REPLACEMENT SYSTEM VARIANCE REQUEST

SUBSURFACE WASTEWATER DISPOSAL SYSTEM APPLICATION

SUBJECT: Division review of failing chamber cluster, Patrick Pelletier property, 13 Forest Avenue, Augusta

Amending permit #1347 issued 8-15-88 do not EC failure of system. Mutual agreement with Police Dept. H.E. 2004

SUBSURFACE WASTEWATER DISPOSAL PLAN

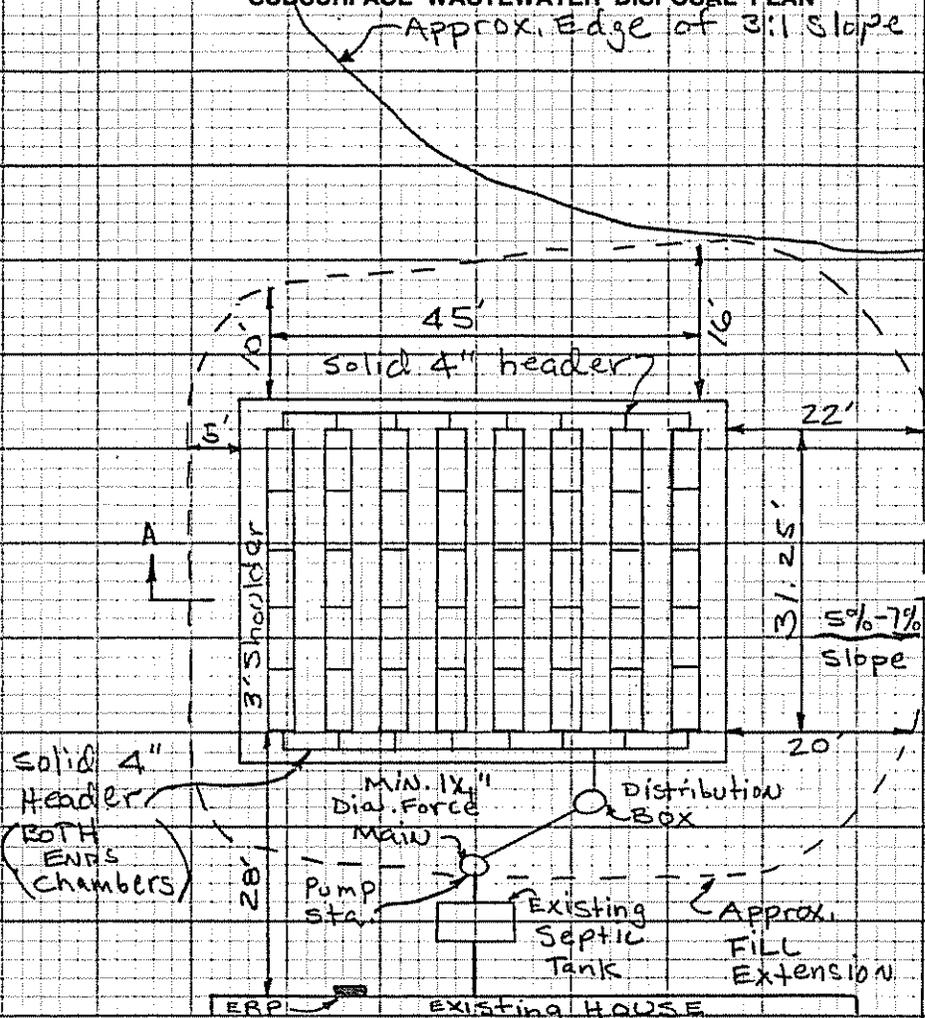
Note: All of old disposal Area was removed prior to installation. ALSO, removed MIN. 24" of fill soil from beneath disposal Area and fill ext. Area & replaced with loamy gravel.

Disposal Area is 40 plastic chamber units in 8 rows (5 units per row) connected by equal distribution.

DISPOSAL AREA CROSS SECTION

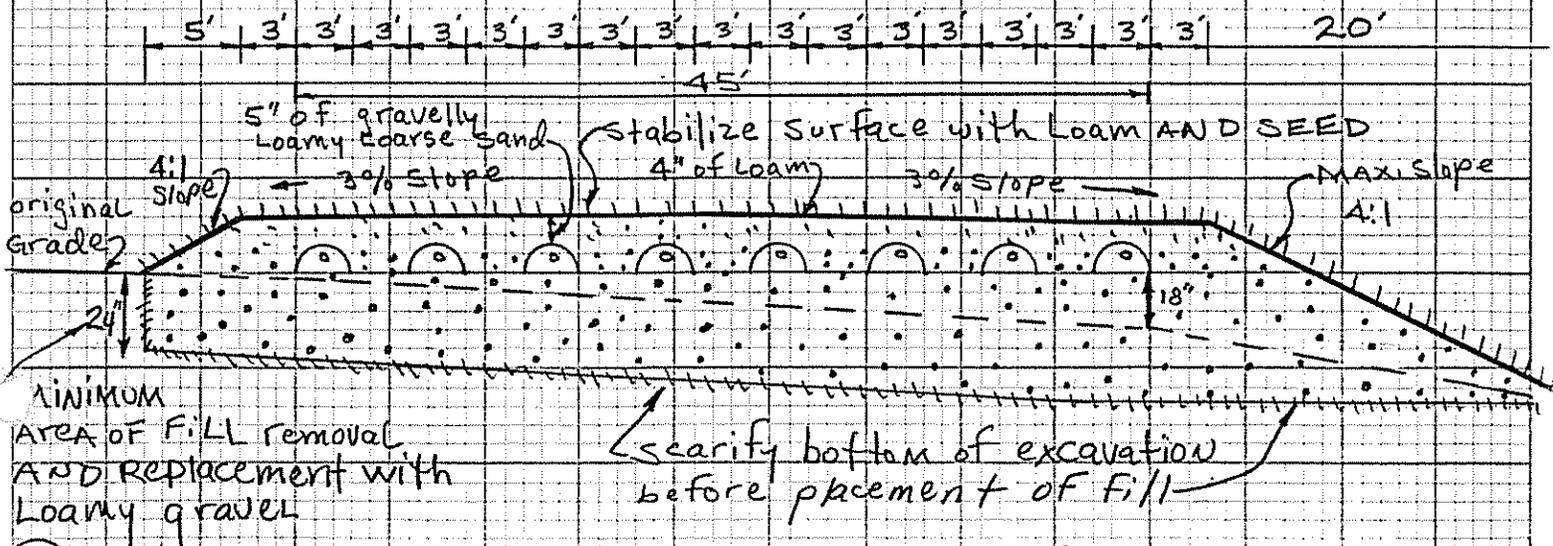
Reference Elevation is 0
Bottom of Disposal Area -36
Top of Distribution Lines or Chambers -24
